**NSLPP MEETING HELD ON 6/10/21****SECTION 4.55 APPLICATION REPORT****Attachments:**

ADDRESS/WARD: 45 Willoughby Street, Kirribilli**APPLICATION No:** D398/19/2**PROPOSAL:** Section 4.55(2) application seeking modifications to Development Consent (D398/19) involving changes to pedestrian access arrangements to a heritage item and the relocation of a skylight.**PLANS REF:**

OWNER: Sylvia and Stuart Terry**APPLICANT:** Filmer Architects**AUTHOR:** Robin Tse, Senior Assessment Officer**DATE OF REPORT:** 23 September 2021**DATE LODGED:** 6 August 2021**RECOMMENDATION:** Approval

Figures 1 – 3: Proposed modifications

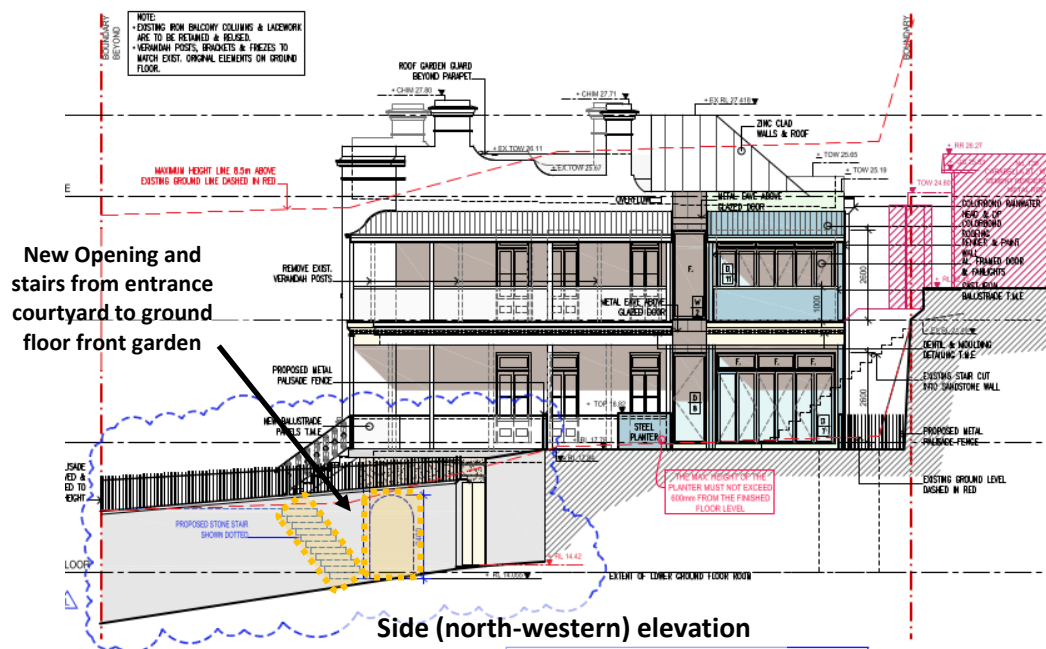
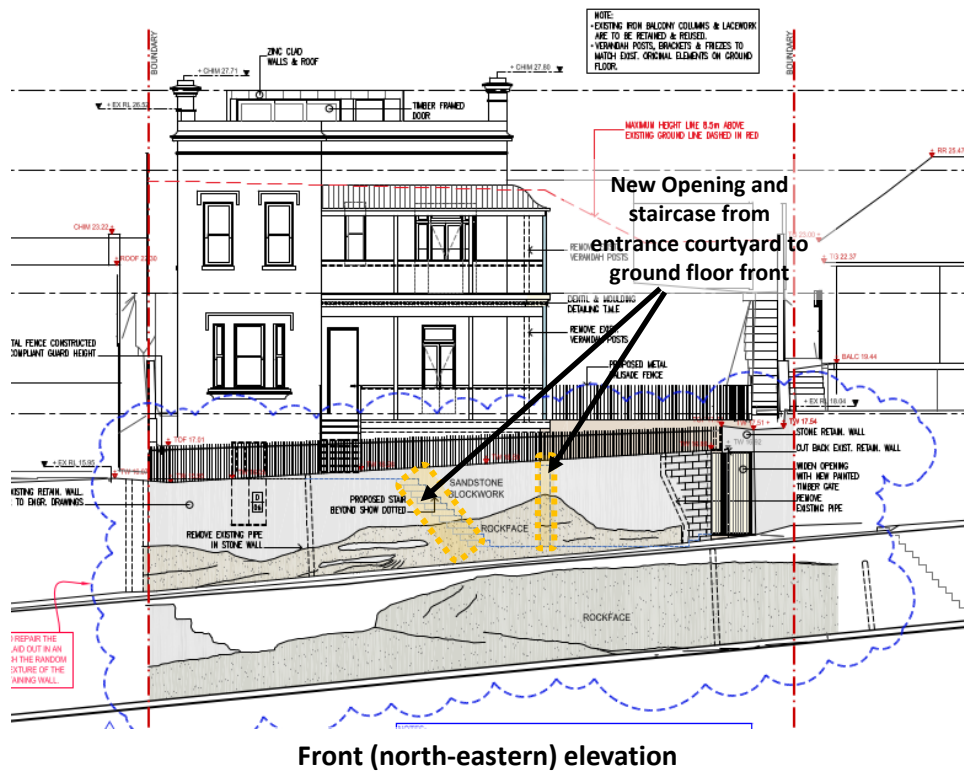
The proposed modifications primarily relate to the relocation of the approved pedestrian access to the ground floor of the dwelling from the side (north-western) elevation to the front (north-eastern) elevation via the construction of a new staircase. The proposed modifications involve the following works:

- (a) Construction of a new pedestrian access through a new opening on the approved retaining wall on the eastern side of the approved entrance courtyard on the lower ground floor;
- (b) Construction of a staircase along the front boundary to provide pedestrian access between the lower ground floor entrance courtyard and the ground floor front garden; and
- (c) Deletion of an approved skylight near the south-eastern (rear) of the *approved* two storey addition and the repositioning of an approved skylight (SK 3) over the first floor bathroom.

Figure 9: The courtyard entry.

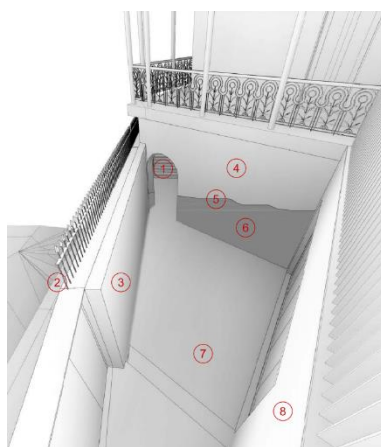
13.9.4 Materials - Objective O1 To ensure that materials and finishes are consistent with the characteristic elements of the heritage item or heritage conservation areas - The materials were resolved in the original DA on the Materials Sample Board Drawing DA 6.1.1 Revision C, drawn by Filmer Architects.

Figure 10: Proposed landscape plan (Ground floor)

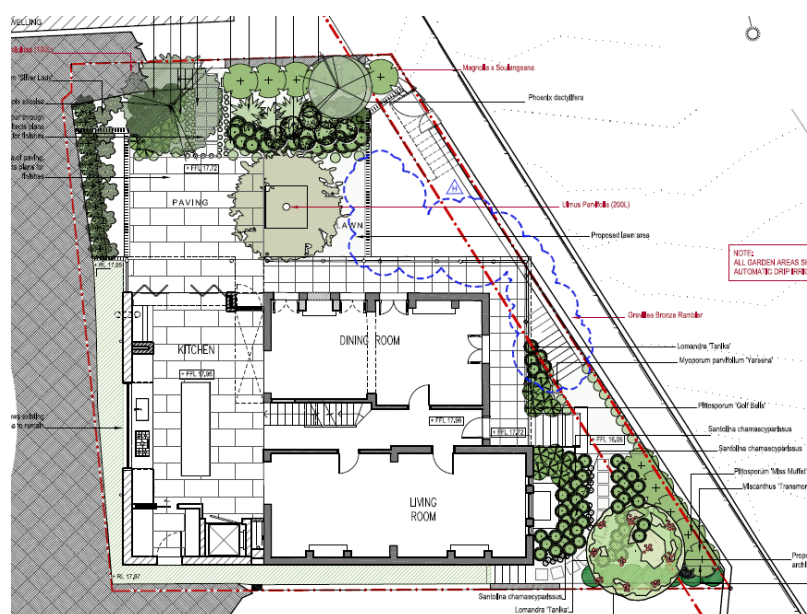
The proposed staircase connecting the lower ground entrance courtyard and the ground floor front garden would affect the landscape treatments within the front garden. Consequently, a landscape plan has been submitted showing the landscaping treatments for the modified proposal with planting adjacent to the new staircase on the ground level.

Figure 11: Building height

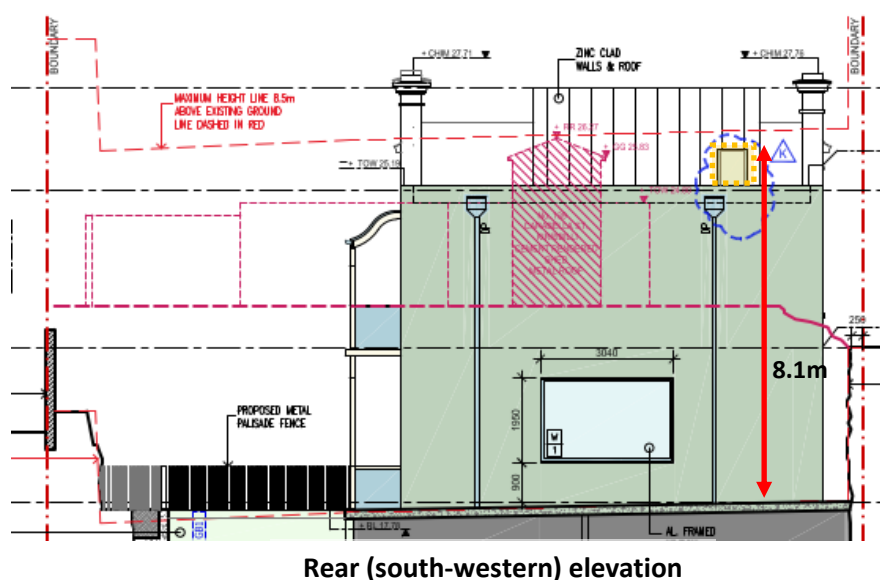
The proposed modifications involve the repositioning of a skylight with a maximum height of 8.1m. The height of this modified building element complies with the permissible height limit of 8.5m in accordance with clause 4.3 in NSLEP 2013.

The proposal would not change the maximum building height of the development at 9.58m as originally approved by NSLPP.

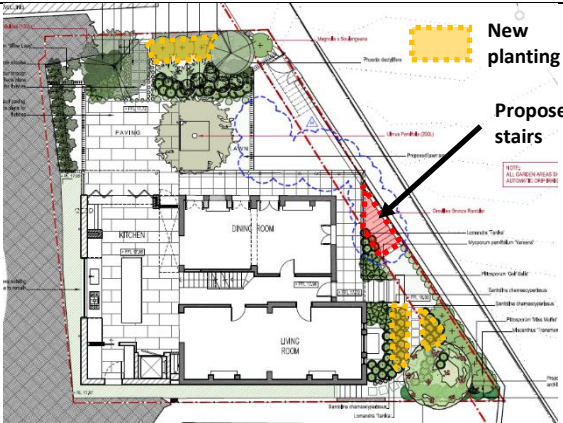
<p>The proposed staircase to the ground floor front garden would increase the unbuilt upon areas by 2.7sqm. The applicant has submitted a landscape plan showing additional planting /landscaping, replacing paved area, within the front garden and the garden area along the south-western side property boundary with a total increase in planting/landscaping by 6.5sqm (Figure 12). The proposal would therefore result in a net increase in landscaping by 3.8sqm or 1.2% of the site area.</p>	Site Area:	Approved	Proposed	Complies	315.6m²				Site coverage (Max 50%)	49.6%	49.6%	Yes	Landscaped area (Min 30%)	13.6%	14.8%	No	Un-built upon area (Max 20%)	36.8%	35.6%	No
Site Area:	Approved	Proposed	Complies																			
315.6m²																						
Site coverage (Max 50%)	49.6%	49.6%	Yes																			
Landscaped area (Min 30%)	13.6%	14.8%	No																			
Un-built upon area (Max 20%)	36.8%	35.6%	No
